### **SAN ONOFRE NUCLEAR GENERATING STATION**

#### **IMPROVED TECHNICAL SPECIFICATIONS CONVERSION**

##### **ITS SECTION 3.3 INSTRUMENTATION**

**ITS 3.3.1, REACTOR PROTECTIVE SYSTEM (RPS)  
INSTRUMENTATION – OPERATING**

Table 3.3.1-1 (page 1 of 3)  
Reactor Protective System Instrumentation

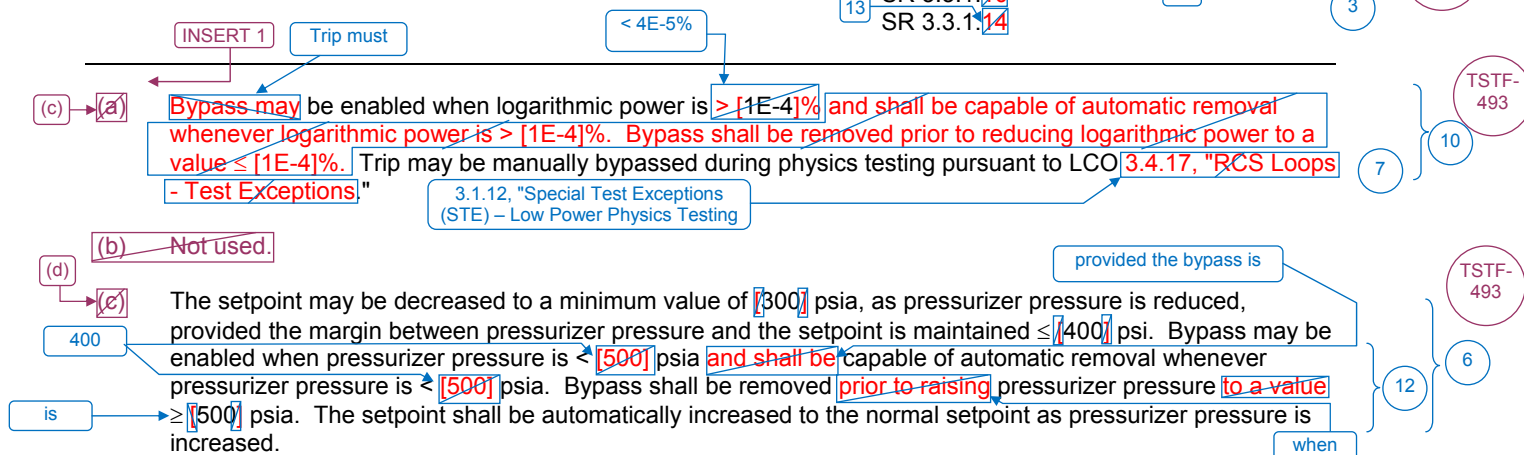
|                             | FUNCTION                             | APPLICABLE MODES<br>OR OTHER SPECIFIED<br>CONDITIONS | SURVEILLANCE<br>REQUIREMENTS   | ALLOWABLE VALUE                 |                    |
|-----------------------------|--------------------------------------|--|--|---------------------------------|--------------------|
| Table 3.3.1-1<br>Function 1 | 1. Linear Power Level - High         | 1,2  | SR 3.3.1.1<br>SR 3.3.1.4<br>SR 3.3.1.6 (a)(b)<br>SR 3.3.1.7<br>SR 3.3.1.8<br>9 SR 3.3.1.10<br>13 SR 3.3.1.14 | $\leq [111.3]\%$ RTP<br>111.0   | 6<br>3<br>TSTF-493 |

Nominal Trip Setpoint (NTSP)

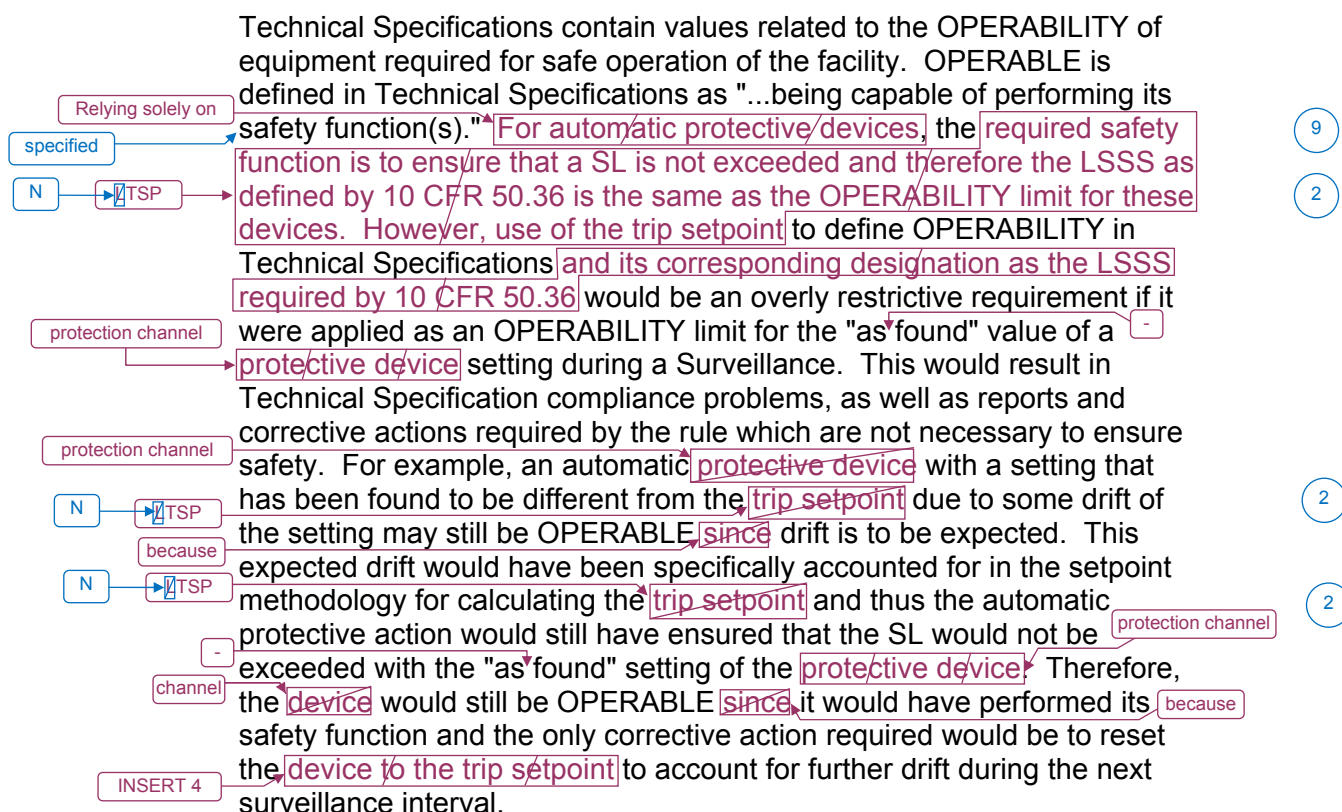
TSTF-  
493**INSERT 3**
